UNITED STATES PATENT AND TRADEMARK OFFICE

Office Action Summary

09/851,970

DETAILED ACTION

FIG. 10

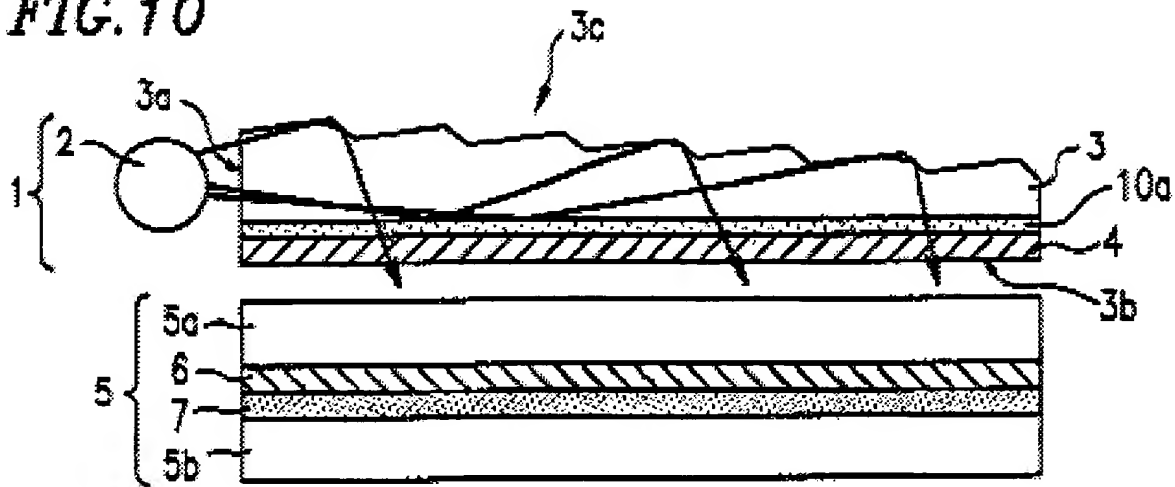
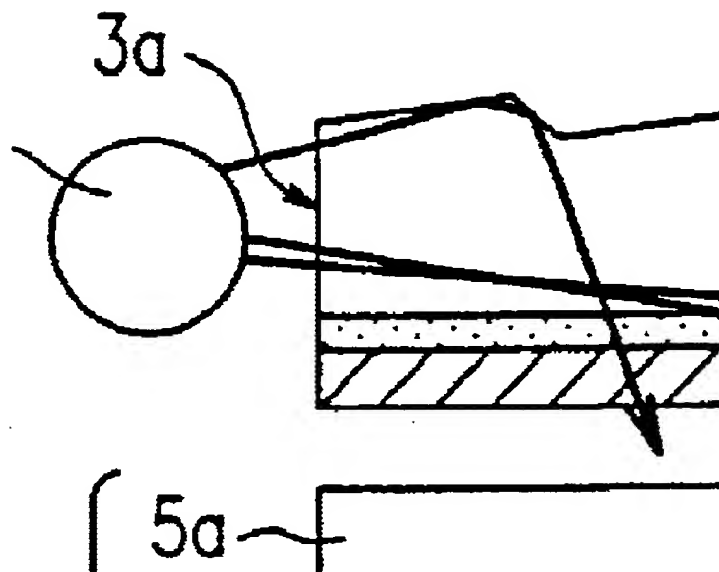
As to claim 1, Masuda discloses in Embodiment 3, Figure 10, (col. 15, line 25 through col. 18, line 16) a reflection type liquid-crystal display device comprising: a reflection type liquid-crystal display panel, 5, including a liquid-crystal cell and a reflector, 7, said liquid-crystal cell having a visual-side substrate, a back-side substrate, 5b, and a liquid crystal, 6, said visual-side substrate including a light guide, 3 (Applicant's transparent substrate), a low-refractive resin layer, 10a (Applicant's transparent layer), lower in reflective index (1.38, col. 15, lines 35-39) than the transparent substrate (1.49, col. 15, lines 35-39), and a transparent electrode (not shown), said back-side substrate having an electrode (not shown), said liquid crystal being held between said visual-side and back-side substrates so that respective electrode sides of said visual-side and back-side substrates are disposed opposite to each other, said reflector being disposed on the back-side substrate side (per Figure 10);

at least one illuminator, 2, disposed on one of side surfaces of said reflection type liquid-crystal display panel; and

an optical path control layer having a repetitive structure of optical path changing slopes, 3c, on an outer side of said visual-side substrate and being higher in refractive index (1.49, col. 15, lines 35-39) than said low-refractive-index transparent layer, each of said optical path changing slopes being inclined at an inclination angle in a range of from 35 to 48 degrees with respect to a reference plane of said visual-side substrate as graphically illustrated by the light path arrow in the upper portion of Figure 10 below.

Masuda does not explicitly disclose and Applicant does not explicitly claim an optical path control layer having a repetitive structure of optical path changing slopes, on an outer side of said visual-side substrate that is not integral to the transparent substrate. However, making integral or making separable the parts of the visual-side substrate are species not considered patentably distinct. It would have been obvious to one having ordinary skill in the art at the time the invention was made to comprise the claimed structure of the visual-side substrate as an art-recognized species suitable for the intended purpose of forming a transparent substrate (MPEP 2144.07).

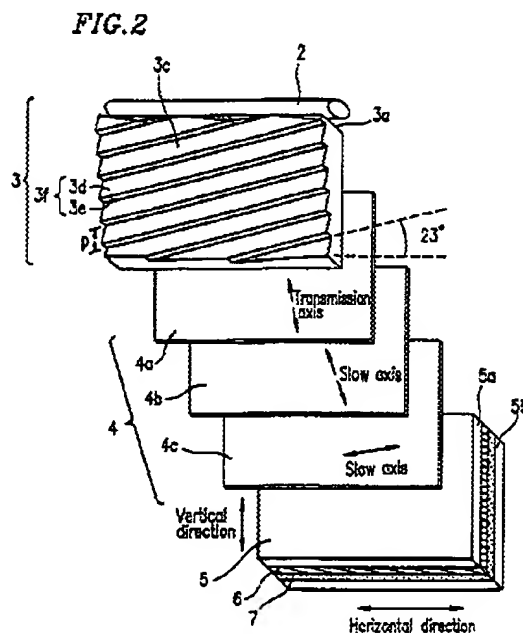
As to claim 3, Masuda discloses a reflection type liquid-crystal display device according to claim 1, wherein at least said visual-side substrate in said liquid-crystal cell is made of polymethylmethacrylate (refractive index 1.49, col. 15, lines 35-39) (Applicant's optically isotropic material).

As to claim 4, Masuda discloses a reflection type liquid-crystal display device according to claim 1, wherein said liquid-crystal display panel further includes one polarizer, 4a, disposed on one side of said liquid-crystal cell (col. 15, line 27-30).

As to claim 5, Masuda discloses a reflection type liquid-crystal display device according to claim 4, wherein said liquid-crystal display panel further includes at least one layer of phase retarder, 4c, disposed between said liquid-crystal cell and said polarizer.

As to claim 6, Masuda discloses a reflection type liquid-crystal display device according to claim 1, wherein: said optical path control layer is constituted by a repetitive structure of prism-like structures, 3f; and each of said optical path changing slopes in said optical path control layer faces said illuminator, 2 (see also Figure 10).

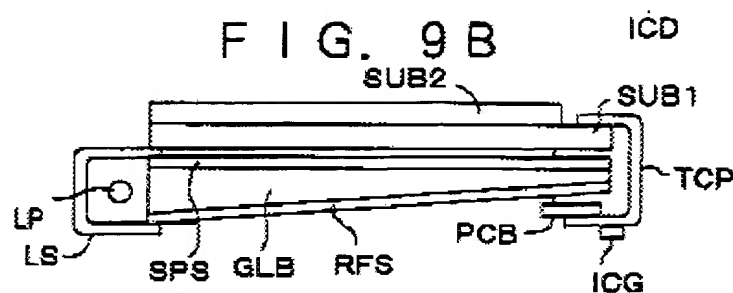
Masuda does not explicitly disclose a device wherein: at least one side surface of said visual-side substrate is protruded outward from that of said back-side substrate; and each illuminator is disposed on said protruded side surface of said visual-side substrate, and wherein each illuminator is disposed and held on said side surface of said visual-side substrate in such a manner that said illuminator is enclosed by a reflection type light source holder and end portions of said light source holder are bonded to end portions of upper and lower surfaces of said visual-side substrate.

Nemoto teaches in Figure 9B the use of a protruded side surface with a light source holder, LS, bonded to end portions of upper and lower surfaces of transparent substrate, GLB, to comprise a lighted display assembly (col. 7, lines 27-32).

Nemoto is evidence that ordinary workers in the art of liquid crystals would find the reason, suggestion, or motivation to add at least one side surface of said visual-side substrate is protruded outward from that of said back-side substrate; and each illuminator is disposed on said protruded side surface of said visual-side substrate, and wherein each illuminator is disposed and held on said side surface of said visual-side substrate in such a manner that said illuminator is enclosed by a reflection type light source holder and end portions of said light source holder are bonded to end portions of upper and lower surfaces of said visual-side substrate to comprise a lighted display.

Therefore, it would have been obvious to one having ordinary skill in the art of liquid crystals at the time the invention was made to modify the LCD of Masuda with the at least one side surface of said visual-side substrate is protruded outward from that of said back-side substrate; and each illuminator is disposed on said protruded side surface of said visual-side substrate, and wherein each illuminator is disposed and held on said side surface of said visual-side substrate in such a manner that said illuminator is enclosed by a reflection type light source holder and end portions of said light source holder are bonded to end portions of upper and lower surfaces of said visual-side
